# Work Order ID 120614

Item ID: D350-607-511 Accept **\*N900040100\*** Setup Start **\*NS1\***  
 Revision ID: Stop **\*NS2\***  
 Item Name: Quick Release Basket Mounting Spacepod™ & Squirrel Cheek Fits LH or RH  
 Start Date: 6/6/2014 Start Qty: 3.00 **\*3\*** Cust Item ID:  
 Required Date: 6/6/2014 Req'd Qty: 3.00 **\*3\*** Customer:  
 Reference: ECN 14-572

# DART SERVICE INSTRUCTION

TO AMEND INSTALLATION INSTRUCTIONS D350-607-3 Rev.D,  
INSTALLATION INSTRUCTIONS D350-607-4 Rev. C AND  
INSTRUCTIONS FOR CONTINUED AIRWORTHINESS ICA-D350-607 REV. 6

**FIGURE 1: INSTALLATION OF D4775-041 FWD STRUT**

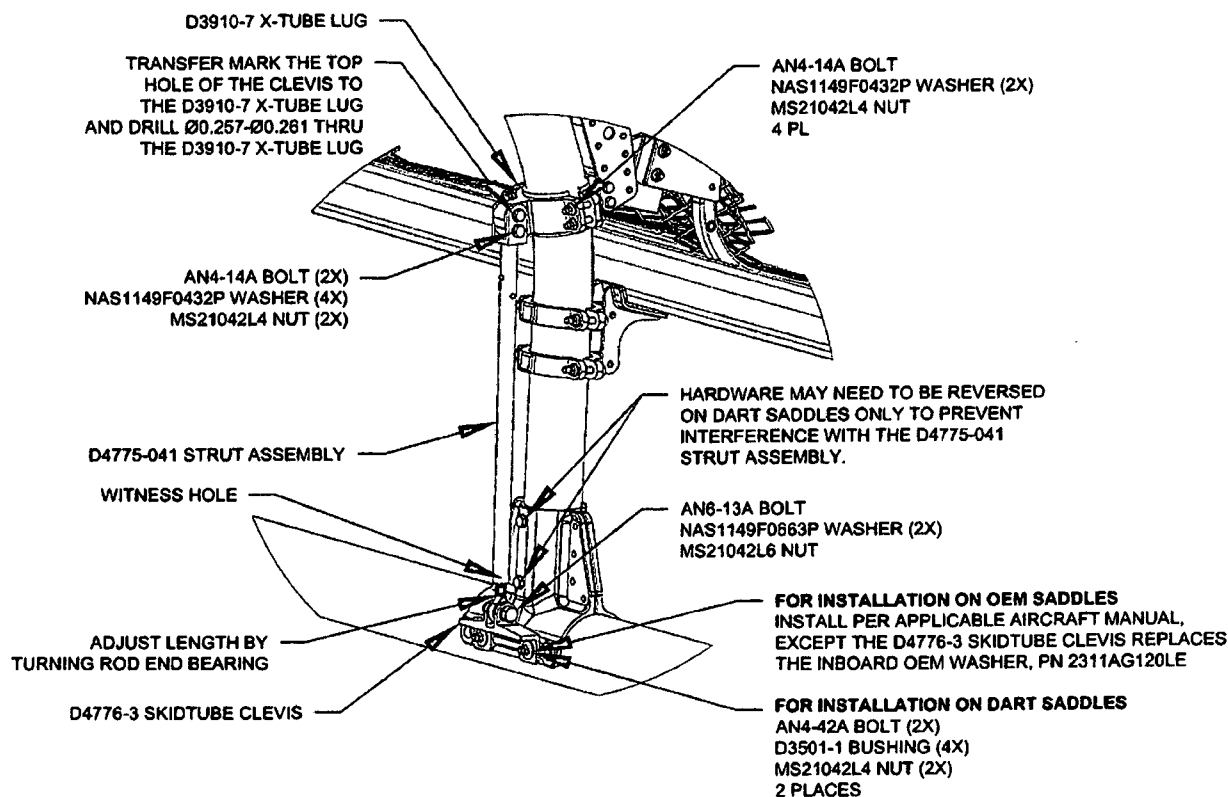
3.1 Substitute the Forward Lower D3910-5 X-Tube Lug with the D3910-7 X-Tube Lug as shown in Figure 1.

3.2 Install the forward D4775-041 Strut Assembly. Transfer mark from the upper hole on the clevis of the D4775-041 Strut Assembly to the D3910-7 X-tube Lug and drill thru the lug  $\varnothing 0.257$ - $\varnothing 0.261$  as shown in Figure 1. Touch up chemical conversion coating per MIL-DTL-5541. Check the witness holes located at the bottom end of the D4775-041 Strut Assemblies to ensure that the thread from the rod end extends past the witness hole.  
**Torque MS21042L4/-4 nuts to 50-70 in-lbs (5.7-7.9 N-m). Torque MS21042L6/-6 nuts to 160-190 in-lbs (18.1-21.5 N-m).**
